FACSIMILE TRANSLATION SUMMARY

FAX FROM: HOME COMPANY/Matsumoto
 FAX TO: IA: Takahashi
 REFERS TO FAX DATED:
 PROBLEM/MODEL: IC-765 antenna switch
 DATE: 2-20-90

SHORT SUMMARY OF MAIN POINTS-
 Re. IC-765 antenna switch unit.

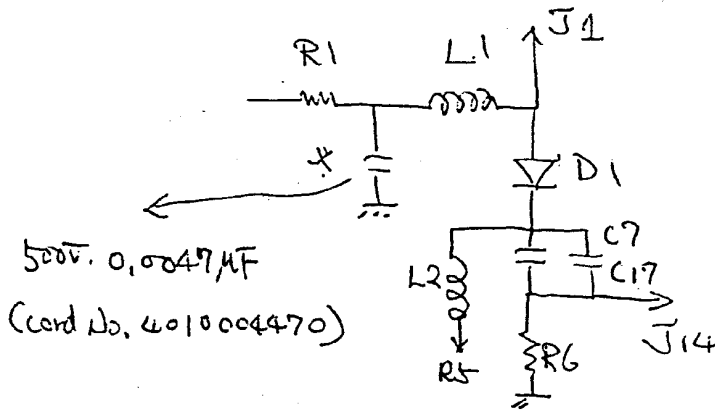
Please try following modification.

Install cap (0.0047uf 500v) between L1 and R1.

This mod. is incorporated in the factory production.
